Certification Labels – Front and Rear Axle Information Reversed

Bulletin Type:	Recall	Publication Date:	November 2025
Bulletin #(s):	25V-736 US	Make(s):	Jayco, Entegra Coach
Job Code(s):	9903641	Model(s):	Granite Ridge, Condor
Flat Rate(s):	9903641 - 0.3 Hr. Labor - Replace Certification Label	Model Year(s):	2025 - 2026

Certification Label

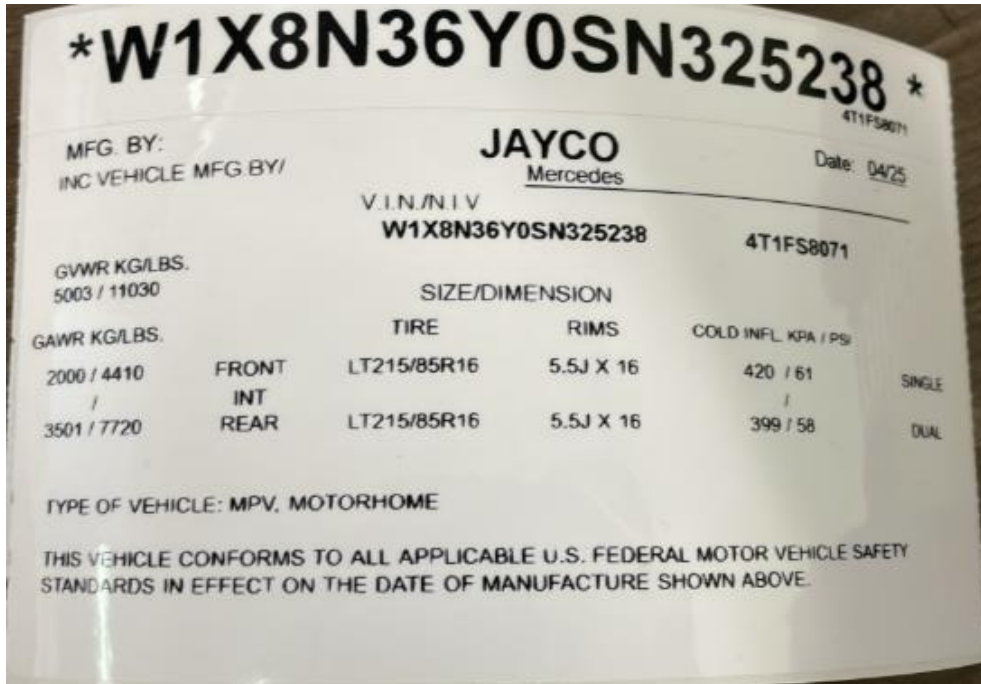
Incident:	Certification labels may have the front and rear axle information reversed due to an internal data entry error.
Affected Units:	2025 - 2026 Jayco Granite Ridge; 2025 – 2026 Entegra Coach Condor
Part:	Part: Certification Label enclosed in owner/dealer notification letter
Misc. Tools & Supplies:	Isopropyl alcohol Shop rag
Parts Return Information:	N/A

The certification label below is only an example of the label you are to replace.

1. Class C Models the certification label will be affixed on the Driver side door B’ pillar (door latch post pillar).
2. Remove the existing label. Using isopropyl alcohol and a shop rag, remove any adhesive residue from the surface where the original label was removed.
 - a. Allow the area to dry for at least 30 seconds.

1. Remove the protective back from the new label. Align the new label in the same location as the original label and apply it to the surface. Remove any air bubbles from the label.
 - a. Note: Do not attempt to remove or adjust the label once it has touched the surface. Doing so may damage the label or cause it not to adhere properly to the surface.
